MONITORING YEAR 2 ANNUAL REPORT FINAL

CARPENTER BOTTOM MITIGATION SITE

RE: Carpenter Bottom Draft MY2 Report Review
Catawba River Basin - HUC 03050102 (03050103 Expanded Service Area)
Gaston County
DMS Project ID No. 100090
Contract #7731

Figure 3 Site Map (Mitigation Plan)

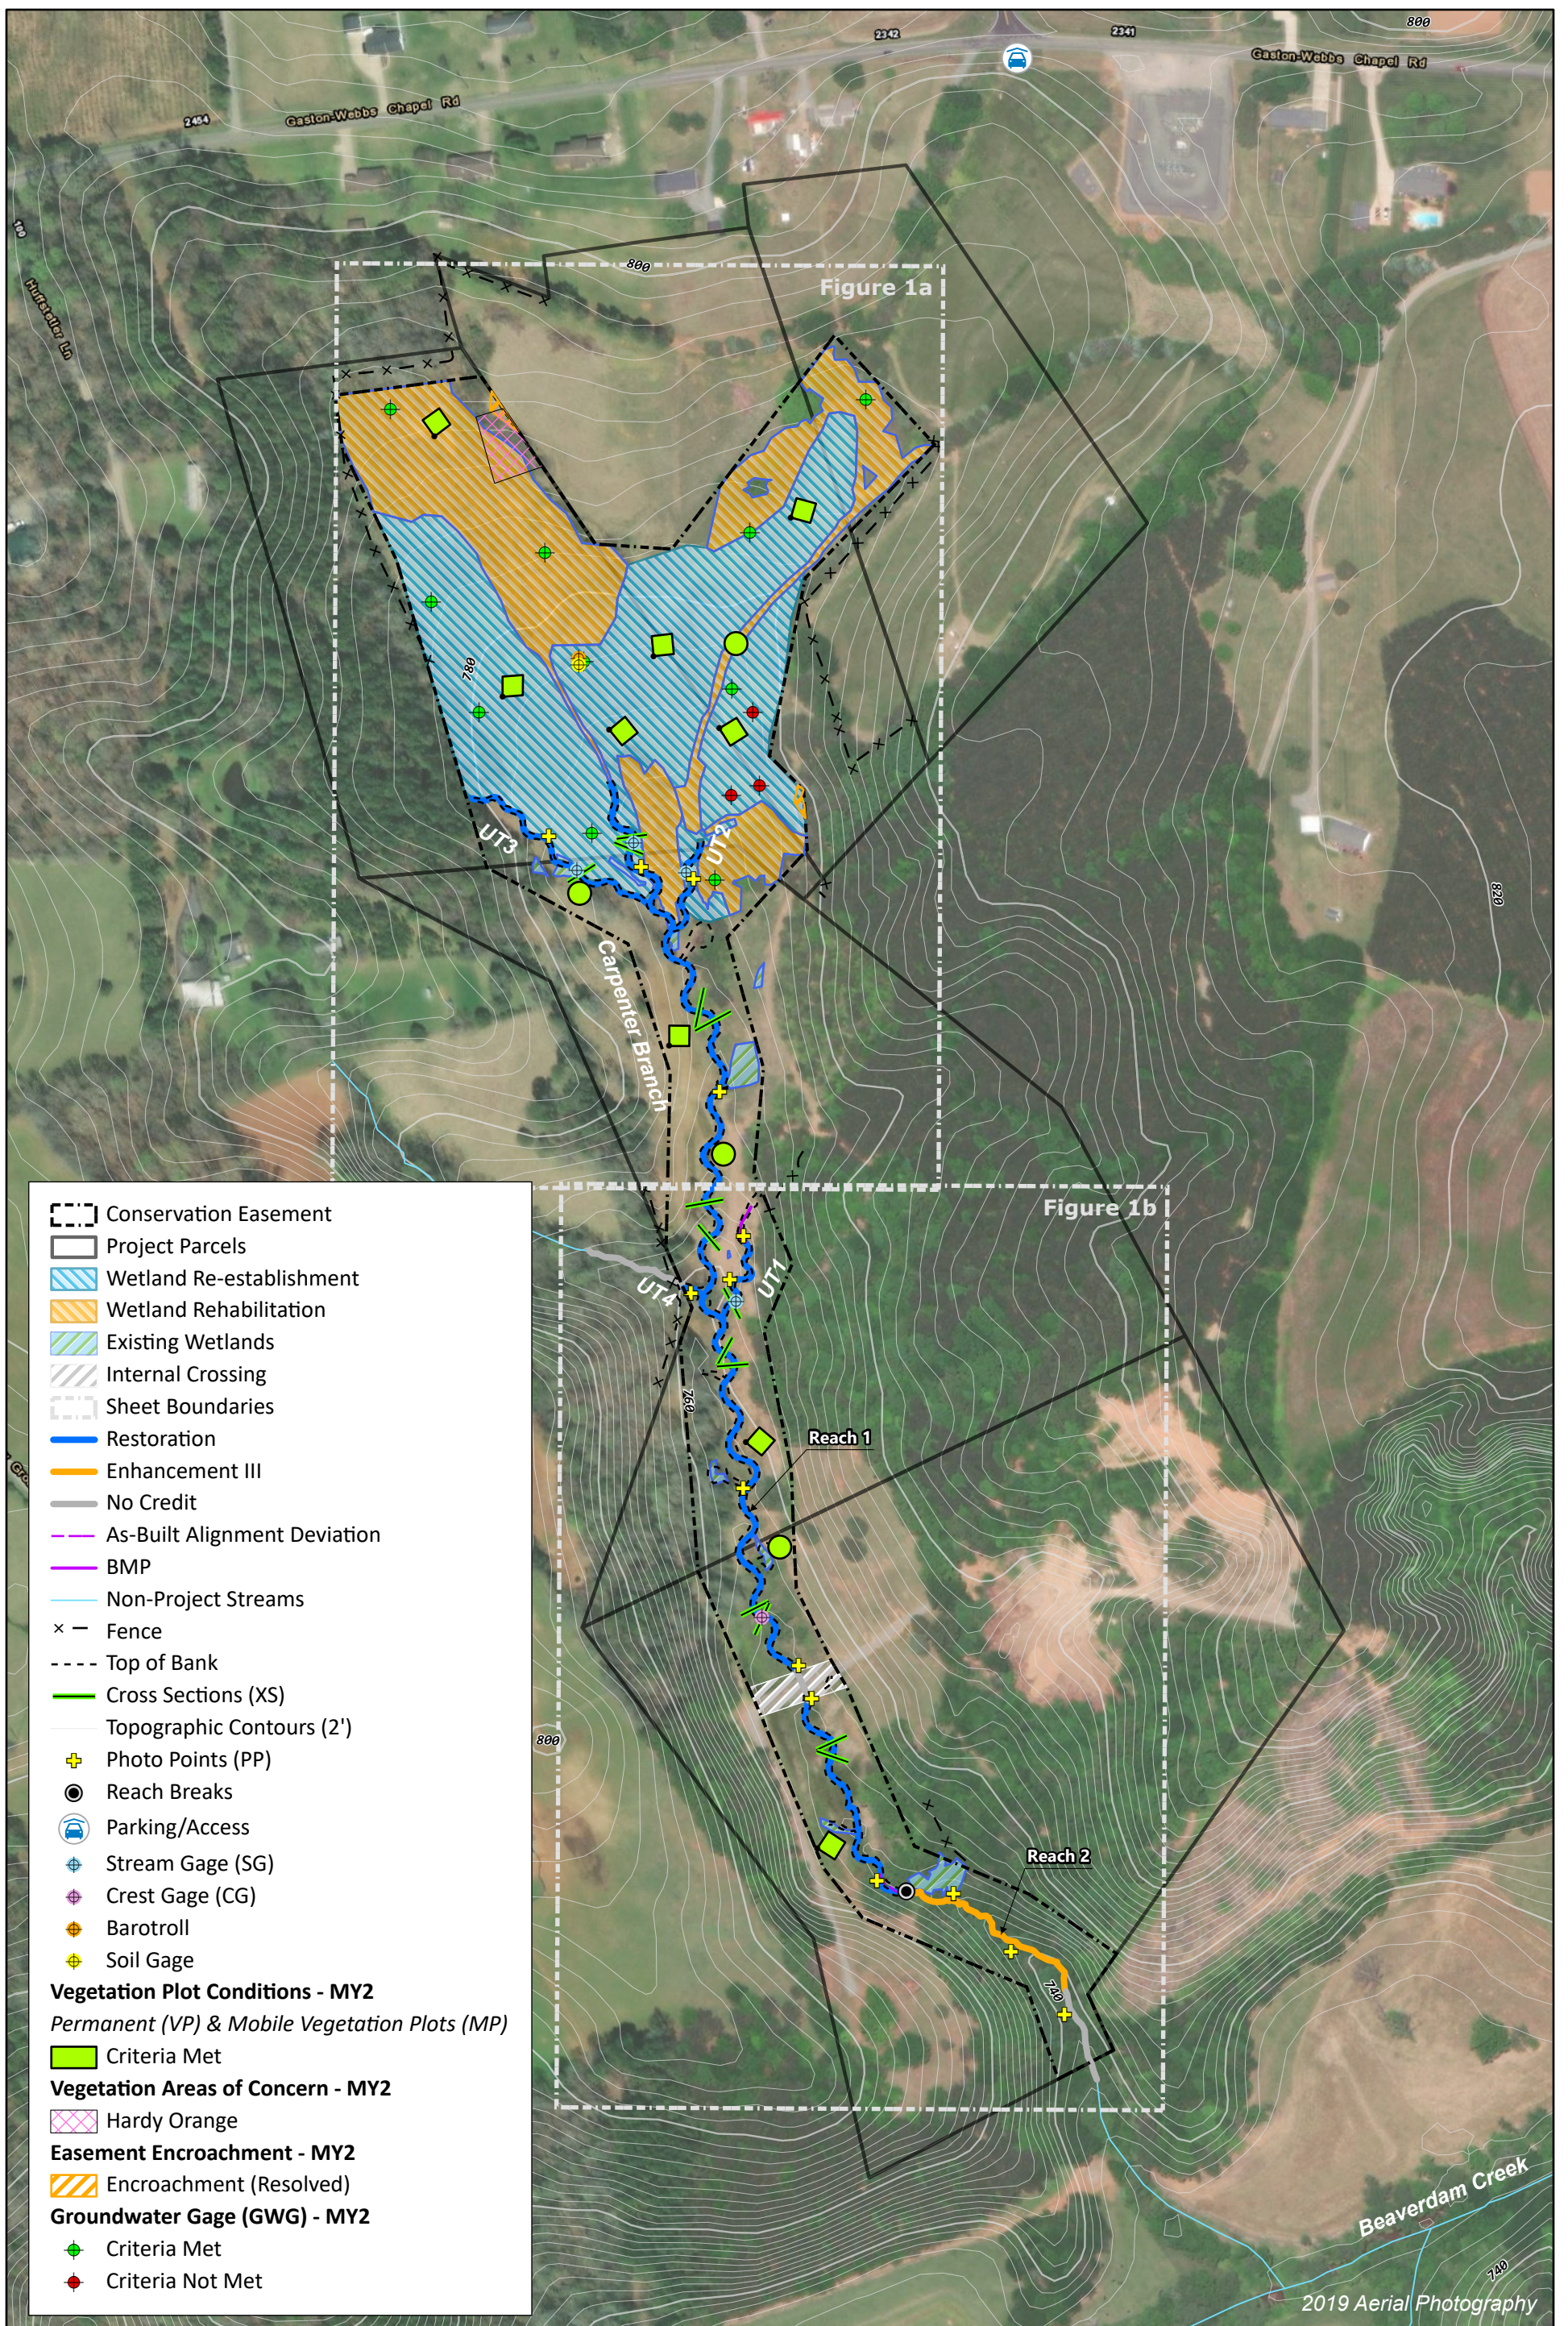
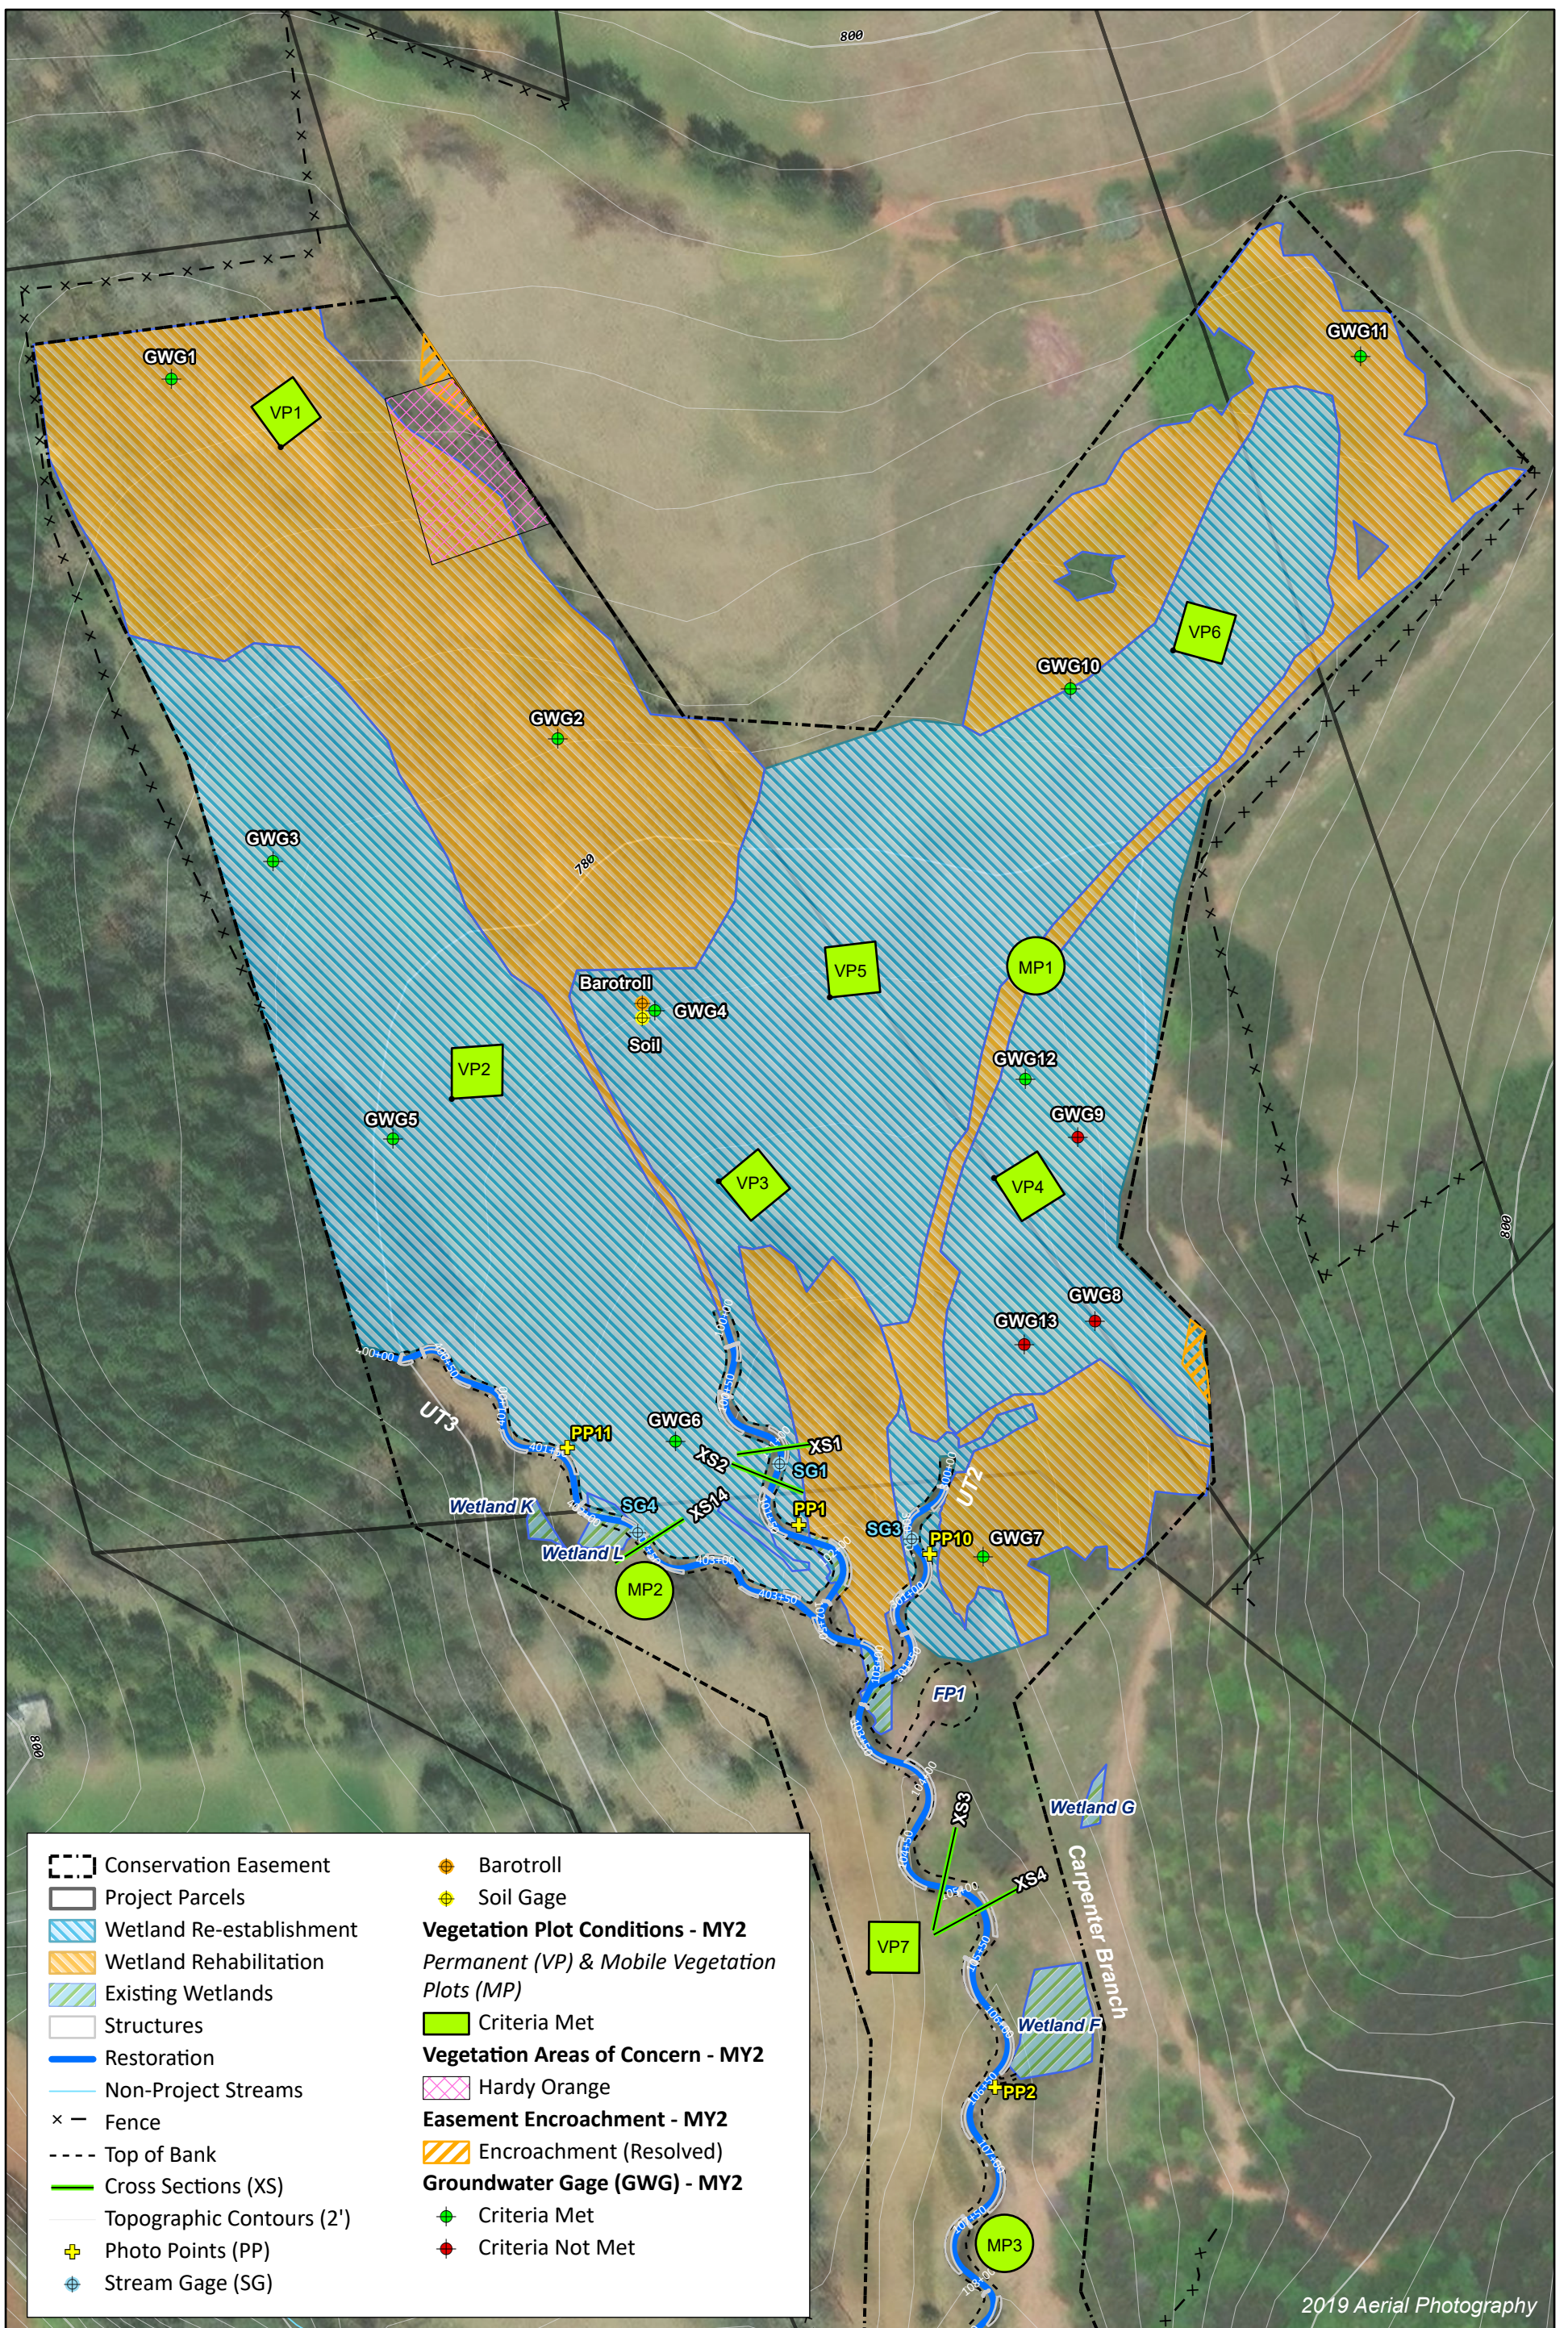
DMS Comment: Recommend either including Figure 3 from the Mitigation Plan and/or adding the six gauges shown in Table 12a to the CCPV so reviewers can easily see the location of the existing conditions gauges compared to the locations of the current monitoring gauges.

Wildlands' response: "Figure 3. Site Map (Mitigation Plan)" was added to the report after the CCPV figures. In addition, the six groundwater gages from the Mitigation Plan are included in the submitted geodatabase.
